Zion Nuclear Power Station, Units 1, 2 and ISFSI
Facility Operating License Nos. DPR-39 and DPR-48
NRC Docket Nos. 50-295, 50-304 and 72-1037

Subject: Radioactive Effluent Release Report, Radioactive Effluent Control Program Report, Offsite Dose Calculation Manual and Process Control Program for 2015

1. Radioactive Effluent Release Report
2. ECN# 400577 Extending liquid effluent discharge line through the discharge tunnel
3. ECN# 400657 Installing additional liquid effluent discharge flowmeters
4. ECN# 400986 Increased capacity dilution water pump of 10,000 gpm and associated flowmeters
5. ECN# 2015-04 Installation of new liquid effluent radiation monitor for 0RT-PR04 and dilution flow permissive for lake discharge valve 0SOV-WD010
6. Current Copy of Zion Station ODCM, Rev. 5

Sketch 3

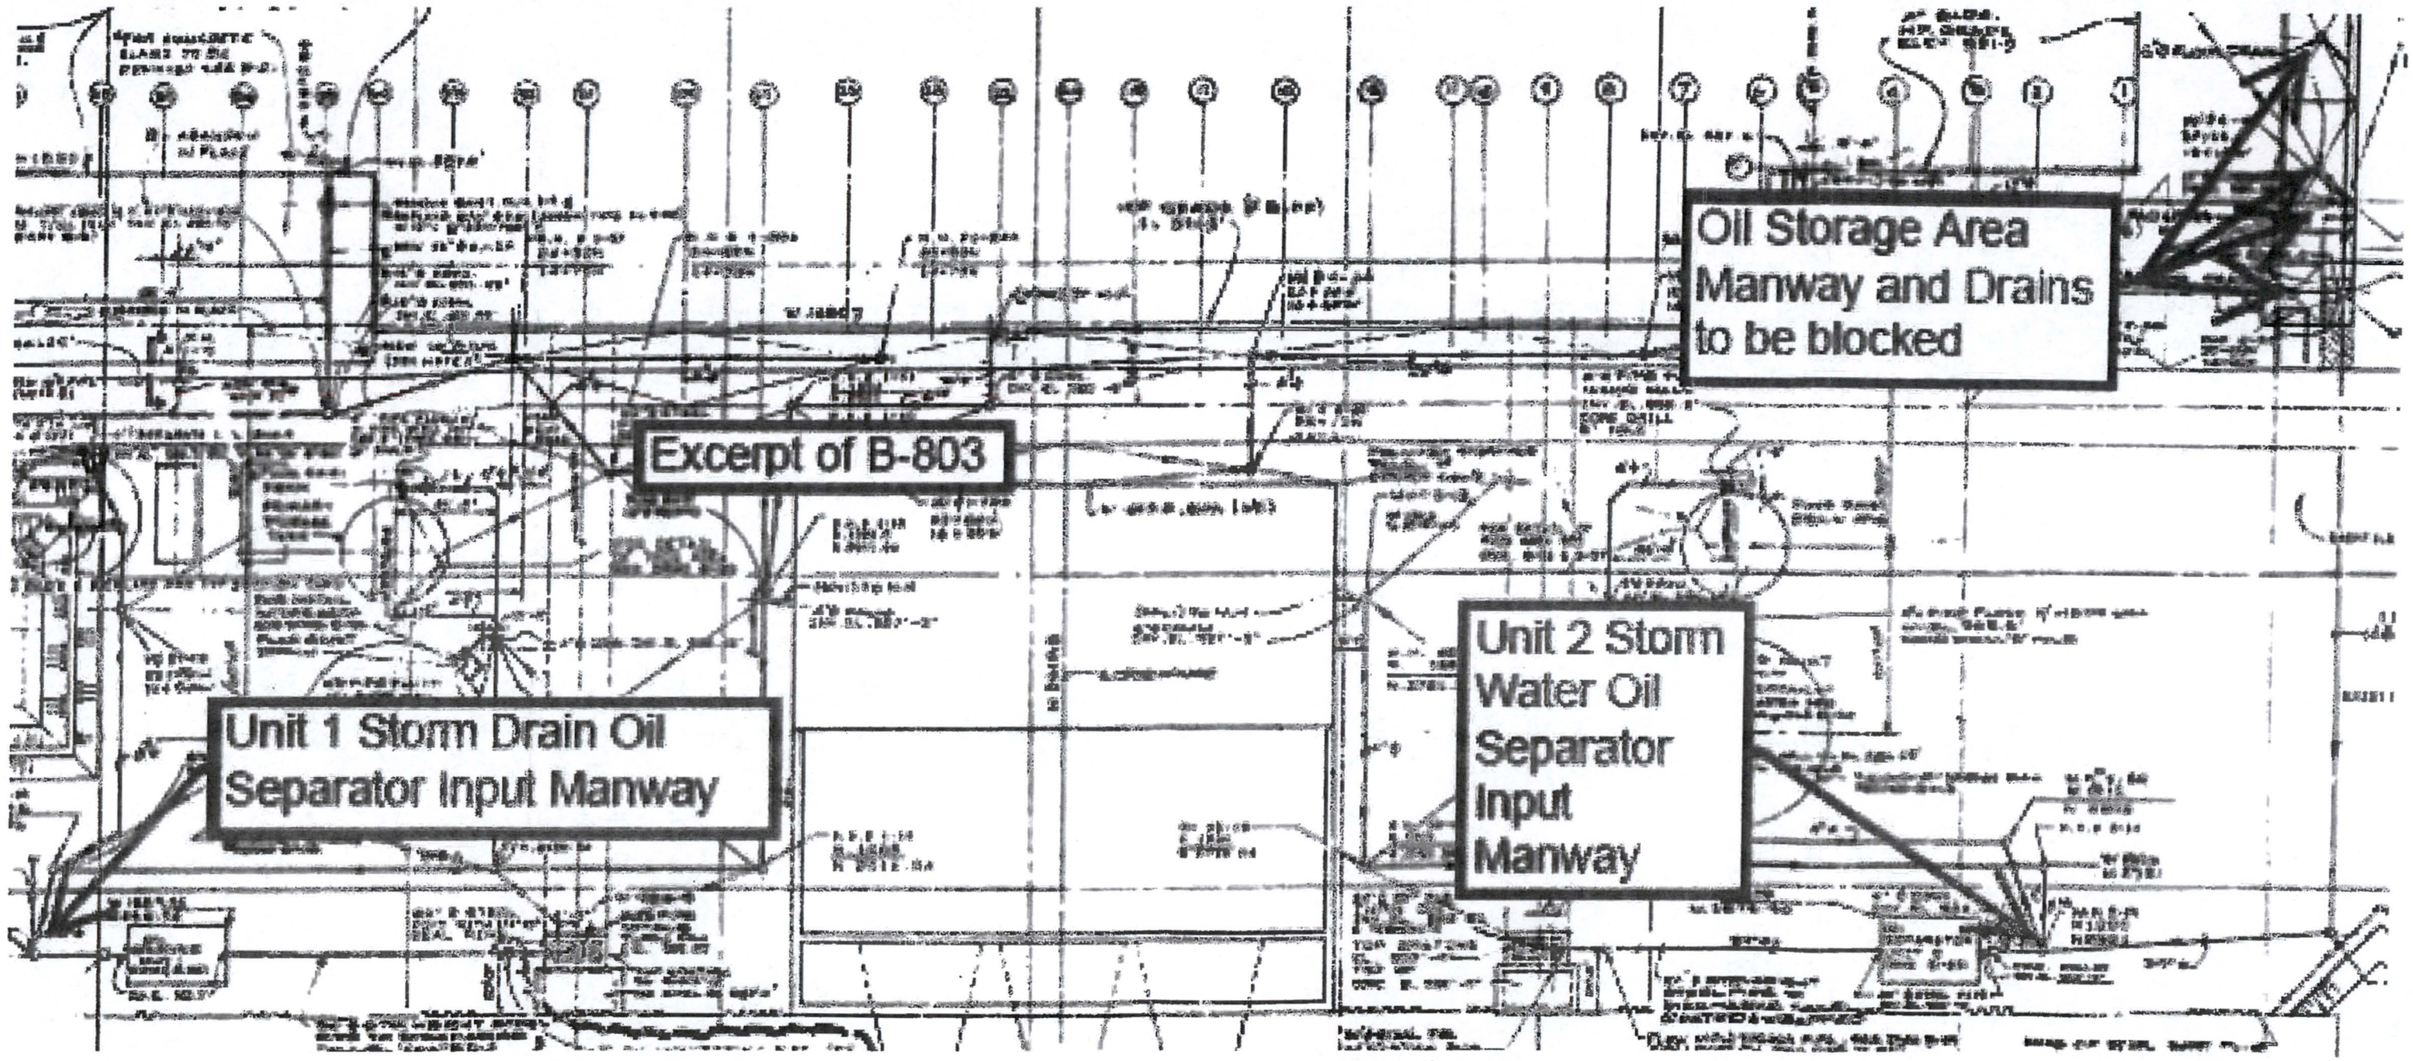
2. At Outdoor Clean and Dirty Oil Storage pads (North of TB) install mechanical plumbers plugs in drains. Remove manhole cover, cut a ¼" steel plate to fit manhole, seal plate to manhole, install manhole cover over plate seal plate. See Sketch 3. Ref B-803, B-876.

3. Use plumbers plugs or similar to plug input and outputs to Man Hole 2-15. Reference drawing B-803, two 4", two 24" See Sketch 3.
4. Fill Man Hole 2-15 with concrete or grout to a minimum of 1 ft above the top of the highest internal pipe. See Sketch 3.

6. Use plumbers plugs or similar to plug input and outputs to Man Hole 1-17 Reference drawing B-803, two 10", two 24", See Sketch 3

7. Fill Man Hole 1-17 with concrete or grout to a minimum of 1 ft above the top of the highest internal pipe. See Sketch 3.
8. Discontinue periodic Sampling of Unit 1 Strom Water Oil Separator Effluent. Notify/Contact Environmental Manager, RP Technical and Chemistry Supervisor.
9. Verify electrically gap the Unit 1 Storm Water Oil Separator Composite Sampler and heat tracing per ECN 400987.
10. Electrically gap the Unit 2 Storm Water Oil Separator Composite Sampler and heat tracing per ECN 400987.

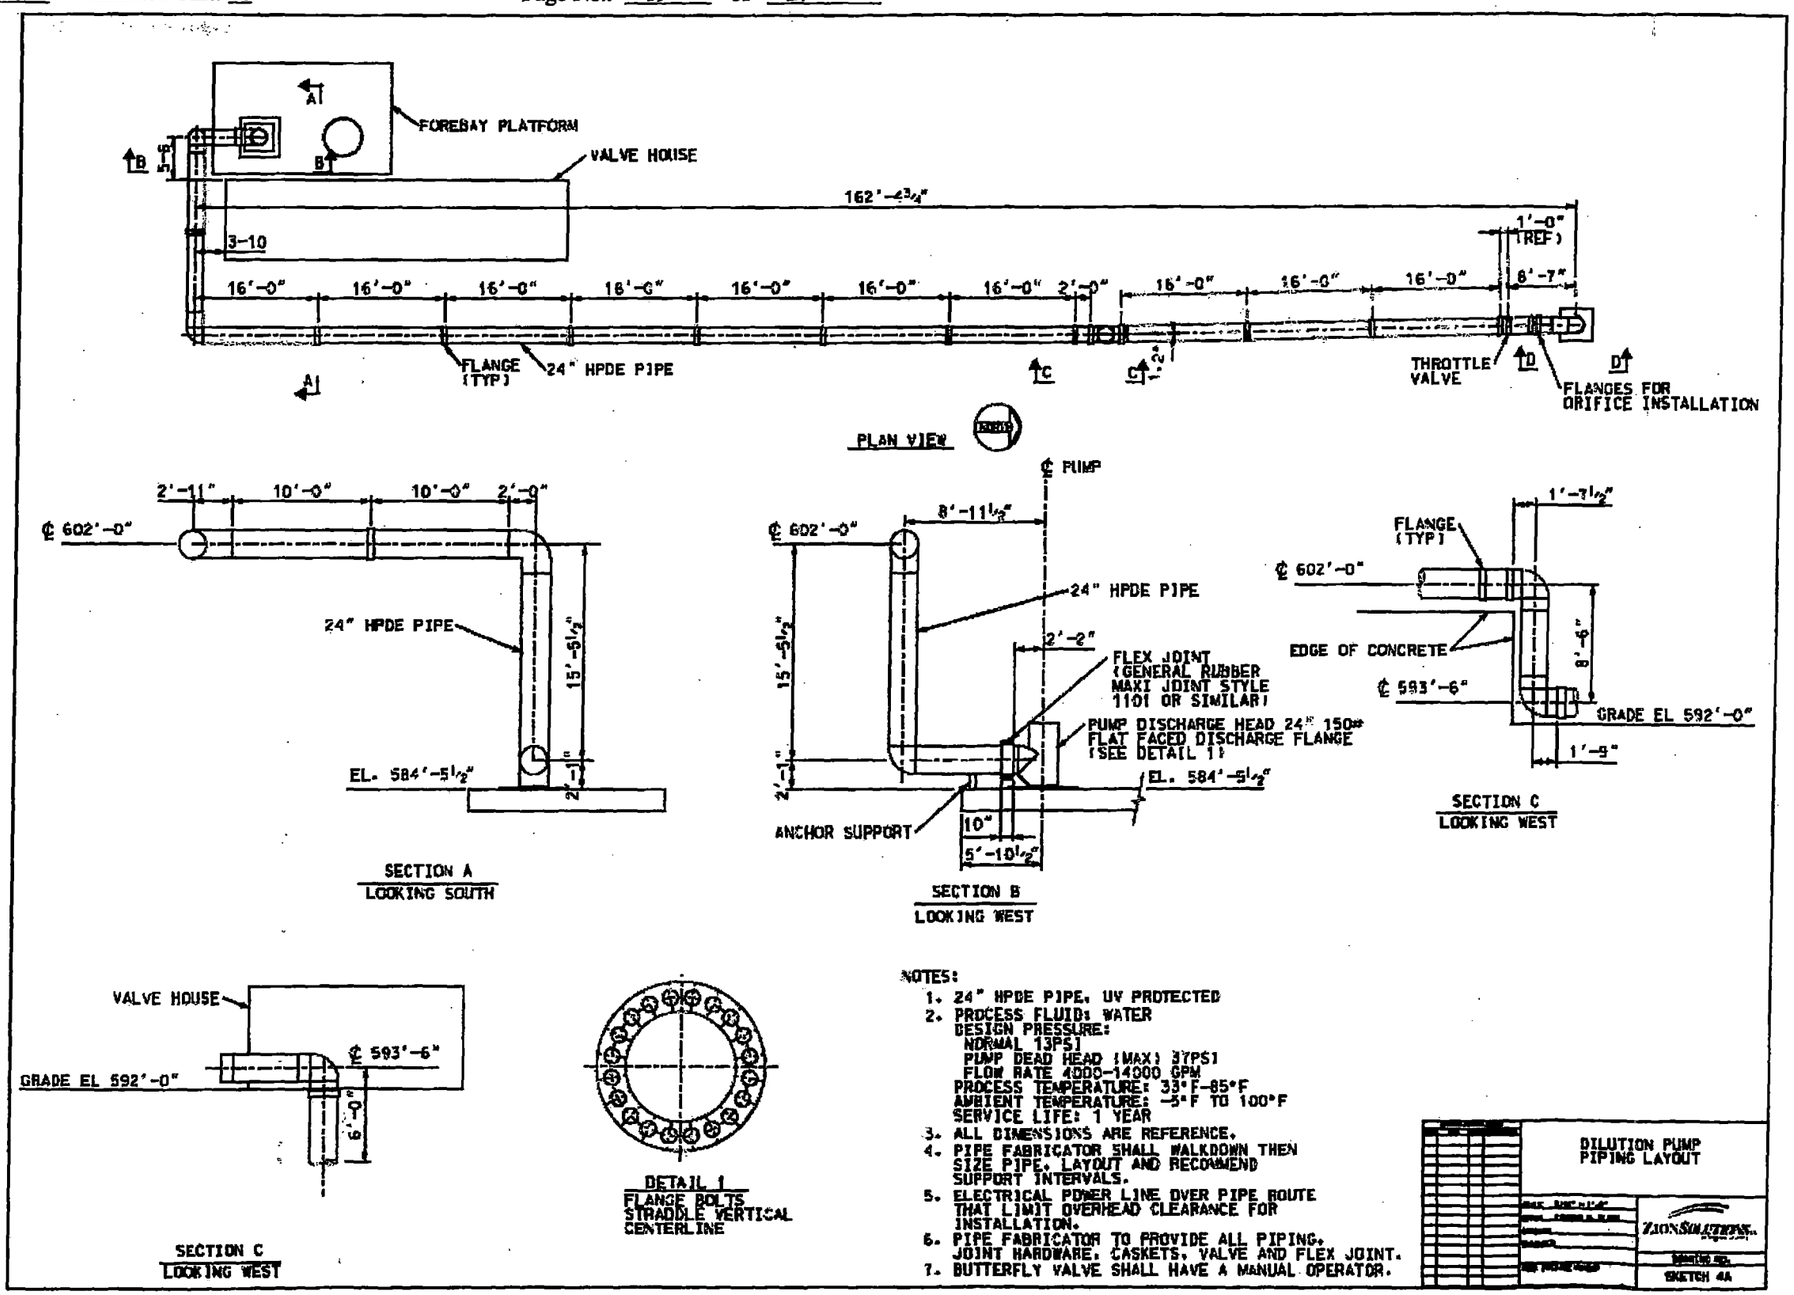
NOTES:
1. 24" HPDE PIPE, UV PROTECTED
2. PROCESS FLUID: WATER
   DESIGN PRESSURE:
   NORMAL 13PSI
   PUMP DEAD HEAD (MAX) 37PSI
   FLOW RATE 4000-14000 GPM
   PROCESS TEMPERATURE: 33°F-85°F
   AMBIENT TEMPERATURE: -5°F TO 100°F
   SERVICE LIFE: 1 YEAR
3. ALL DIMENSIONS ARE REFERENCE.
4. PIPE FABRICATOR SHALL WALKDOWN THEN SIZE PIPE, LAYOUT AND RECOMMEND SUPPORT INTERVALS.
5. ELECTRICAL POWER LINE OVER PIPE ROUTE THAT LIMIT OVERHEAD CLEARANCE FOR INSTALLATION.
6. PIPE FABRICATOR TO PROVIDE ALL PIPING, JOINT HARDWARE, GASKETS, VALVE AND FLEX JOINT.
7. BUTTERFLY VALVE SHALL HAVE A MANUAL OPERATOR.

Sketch 6
Located on pump platform on pipe side of flex joint

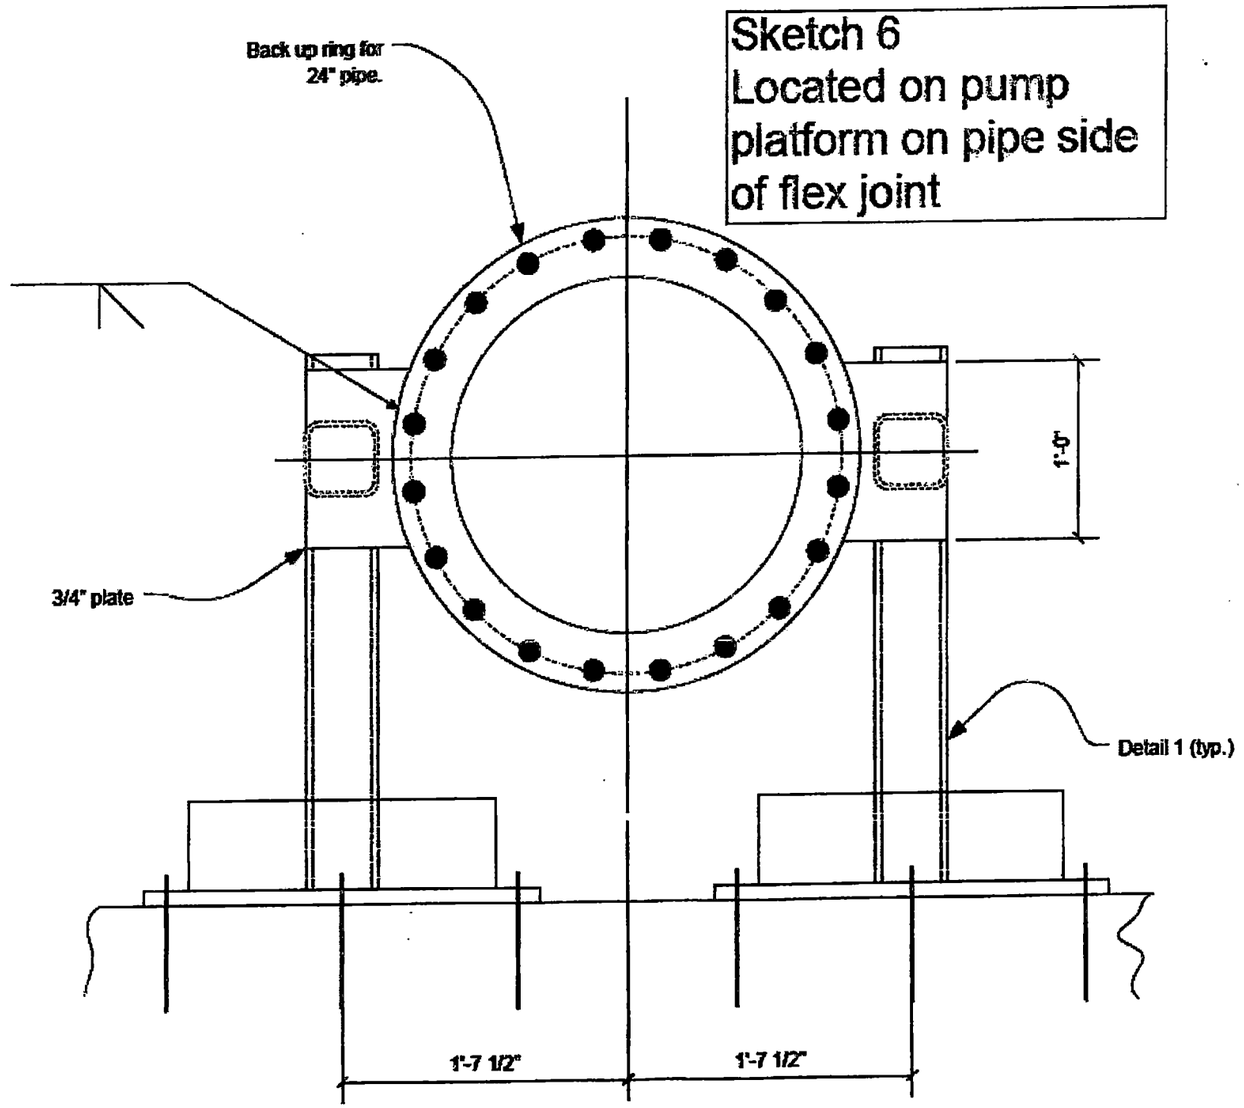
10. Install flexible boot to pump per Sketch 4A, photo 7.
11. Install riser pipe per Sketches 4A, 4B and Pipe Fabrication Vendor drawing and instructions. (Engineering to review and approve vendor drawings and instructions)
12. Install pipe anchor per Sketches 5, 6 and 7.

Sketch 3

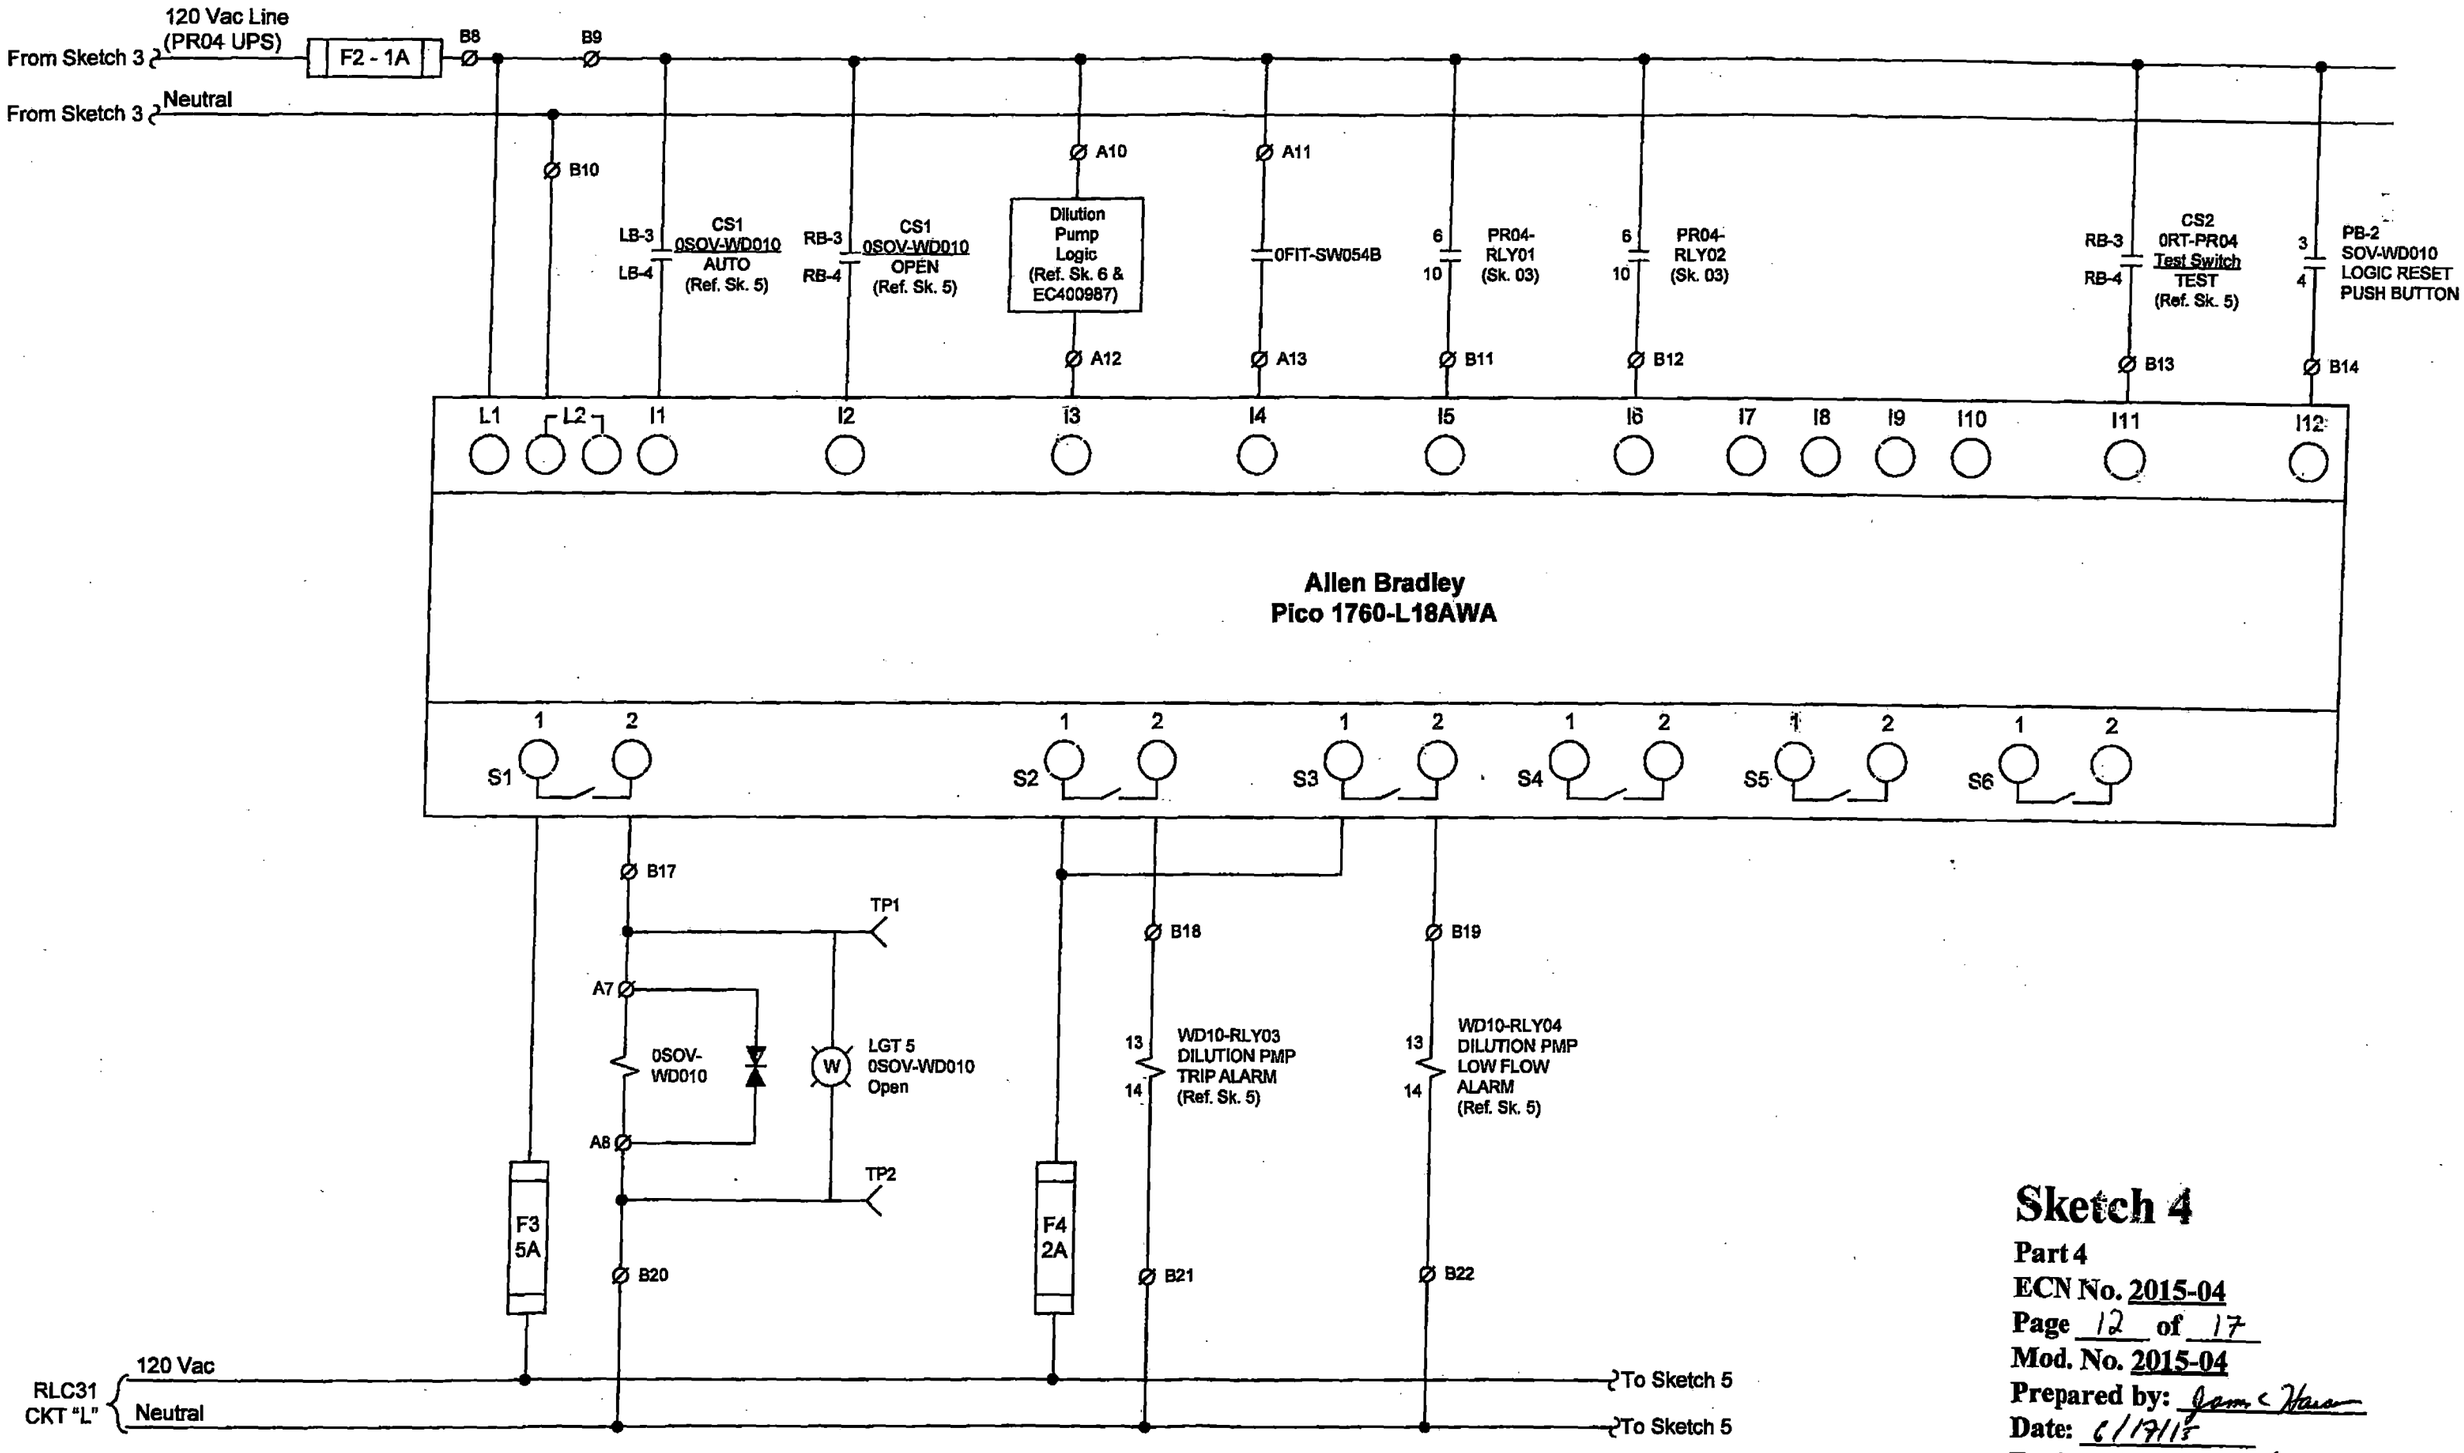
3.f. At PR04/WD010 control panel, PRESS PR04 Alarm Reset Push Button and VERIFY relays PR04-RLY01 and PR04-RL02 energize and remain energized (Ref. Sketch 3).
